PRODUCT CHANGE NOTIFICATION (PCN)

A-MCUP-80005/B MODULAR CABLE

CHANGE NOTIFICATION: PCN 20220425_A-MCUP-80005/B

ASS 7407 CA

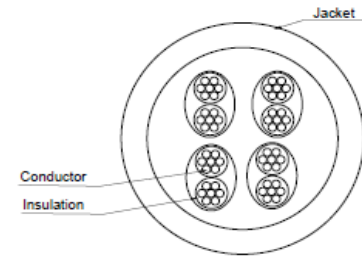
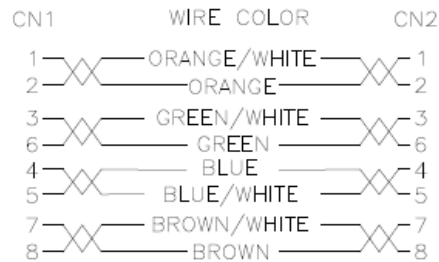
DESCRIPTION OF CHANGES: CHANGE OF DATA SHEET
CHANGE OF DATA SHEET
New Draw.-No. ASS_7407_CArev04

REASON FOR CHANGE: CHANGE OF PRODUCT LOCATION
CHANGE OF PRODUCT LOCATION

NO.	NAME.	QTY	SPECIFICATION																																
③	Molding PVC	2	Molding PVC 45P																																
②	RJ45 CONN	2	RJ45 8P8C, Two Fork gold plated contacts 3u" gold																																
①	CABLE	1	UTP(26AWG*x1PR)*4+PVC OD:4.9±0.2mm																																
NO.	NAME.	QTY	SPECIFICATION																																
④	⚠ Molding PVC	2	Molding PVC 65P																																
④	⚠ RJ45 CONN	2	RJ45 8P8C, contacts 3u" gold-plated Un-shielded PC UL94V-2																																
④	⚠ CABLE	1	CAT 5E U/UTP(26AWGx1PR)*4+PVC Jacket OD:4.9±0.2mm																																
<p>FOR DETAIL, PLEASE TAKE ATTACHED NEW DRAWING: FOR REFERENCE</p>

④	△	Molding PVC	2	Molding PVC 65P
④	△	RJ45 CONN	2	RJ45 8P8C, contacts 3u" gold-plated Un-shielded PC UL94V-2
④	△	CABLE	1	CAT 5E U/UTP(26AWGx1PR)*4+PVC Jacket OD:4.9±0.2mm
